MEMORANDUM

CSP2014 0018

A City Consistency permit for temporary parking at the 'Bridge Park'

under the Juneau-Douglas Bridge.

ATTACHMENT A

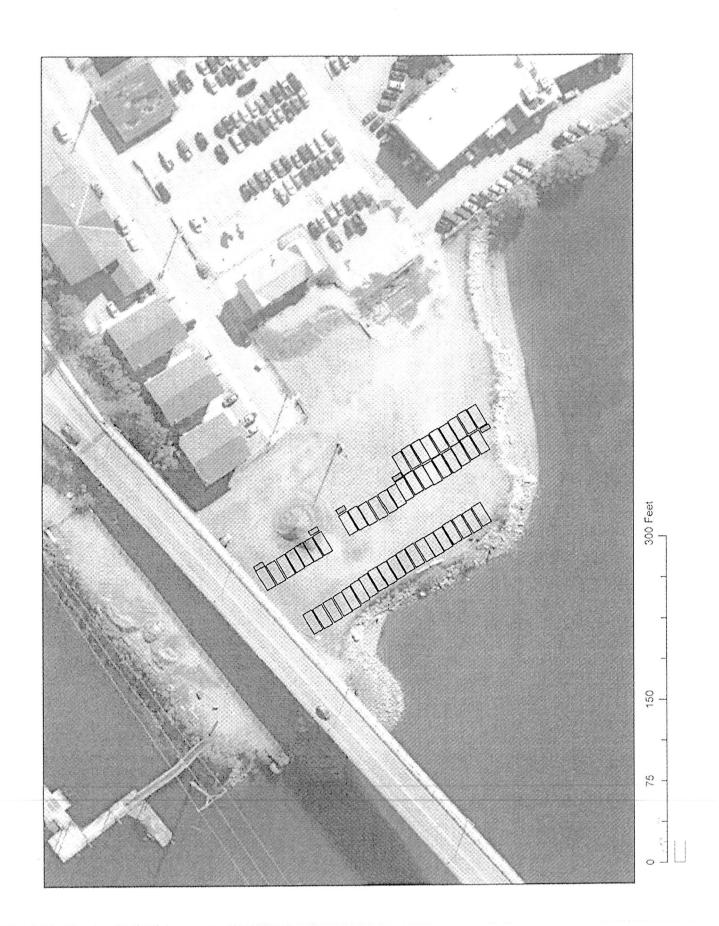
Through 49.40.220(a) parking areas shall be properly drained, lighted, and landscaped. Installing permanent drainage, lighting, and landscape infrastructure for a temporary parking lot would not be appropriate for this project. Further, since the Bridge Park design has not yet been finalized, installing infrastructure at this time may need to be removed for later for the future park elements. Therefore, installing permanent infrastructure according to 49.40.220(a) isn't appropriate for this project. With that said, staff finds that cars parked along the shoreline may leak oils, coolants, and other toxins into the ocean and harm aquatic habitat. The applicant shall submit a drainage plan that ensures proper filtration of toxins before drainage enters the ocean.

Through 49.40.220(e) parking stalls and access aisles shall be clearly marked. Since the parking area won't be paved, wheel stops should be utilized to mark each parking stalls.

Per 49.70.925(g), parking along the shoreline must be setback at least 10-feet whereby a vegetated buffer shall be installed to filter water run-off from the parking lot. The submitted parking plan show parking stalls next to the edge of the shoreline. To meet the purpose of 49.70.925(g), staff finds that in addition to ensuring proper drainage the parking stalls shall be moved away from the edge of the shoreline at least 10 feet. There is ample space on the site to locate spaces away from the shoreline edge, as well as keeping clear of CBJ Public Works' gravel trucks.

- 1) The approval of the subject CSP shall expire at the end of the CBJ's Lands & Resources Dept. temporary use permit or the discontinuation of the parking lot, whichever is sooner.
- 2) Prior to construction, a drainage plan shall be submitted to the CDD that indicates how surface water run-off will be adequately addressed.
- 3) Prior to final inspection, wheel stops shall be placed at each parking stall.
- 4) Full parking lot infrastructure and landscaped buffer must be installed if the parking lot is approved for use past its expiration, unless determined otherwise by the CDD Director.
- 5) The parking stalls shall be at least 10 feet away from the top edge of the bank of shoreline, where feasible.
